**BEFORE THE BOARD OF ZONING ADJUSTMENT
OF THE DISTRICT OF COLUMBIA**

**Appeal of the Chain Bridge Road/University Terrace
Preservation Committee**

**BZA Appeal No. 20221
Hearing: June 10, 2020
ANC 3D05**

**APPELLANT'S CONSOLIDATED REPLY TO DCRA'S AND PROPERTY OWNER'S
PRE-HEARING STATEMENTS**

ASSESSMENT AND TAXATION PLAT
Square 1425

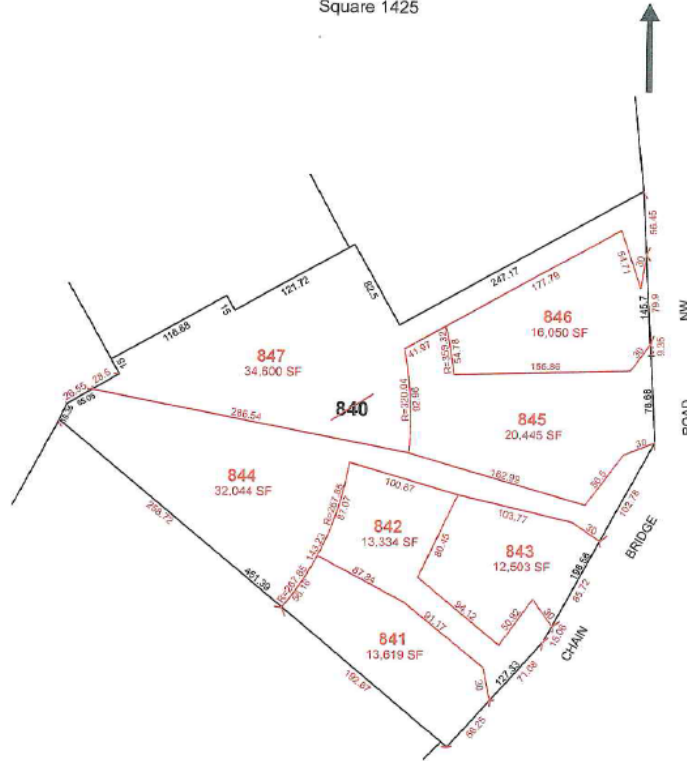
The Zoning Determination Letter correctly determined the obvious – the seven proposed lots were “irregularly shaped.”

In fact, the Zoning Regulations provide specific and controlling guidance in this situation. For an irregularly shaped lot, compliance with the lot width requirement cannot properly be determined based on the narrow Rules of Measurement set forth in Subtitle C-§304.1. The Zoning Determination Letter failed to follow the clear and directly applicable guidance provided in the established definition of “Lot Width” set forth in the Zoning Regulations.

The Zoning Administrator and the Property Owner have not reviewed or provided the required average lot width calculations for the seven proposed and irregularly shaped lots. Although not specified in the regulations, there are at least four Board recognized methods for calculating average lot width that have been used by the Zoning Administrator historically. BZA Appeals Nos. 15129 and 15136 (1992) (10-foot interval, average, mean depth and greatest depth methods).

In this case, the “Ten-Foot Interval” method seems best suited to the highly irregularly shaped and pipe stem lots proposed. This method is simple to calculate based on linear measurements of the lot width at 10-foot intervals. The total linear length of all lot widths is then divided by the number of 10-foot intervals to calculate the average lot width.

<u>LOT</u>	<u>TOTAL LINEAR MEASUREMENT</u>	<u># OF 10-FOOT INTERVALS</u>	<u>AVERAGE LOT WIDTH</u>
841	1,322.66	19	69.61
842	1,147.61	20	57.38
843	1,186.91	12	98.9
844	3,405.2	49	69.49
845	2,096.78	21	99.85
846	1,476.21	17	86.84
847	3,292.78	48	68.60

Lots 841, 842, 844 and 847 each have an average lot width less than the minimum 75 feet required. Not surprisingly, the most irregularly-shaped lots, especially the disfavored pipe stem lots, failed to comply with the average lot width required by the Zoning Regulations.
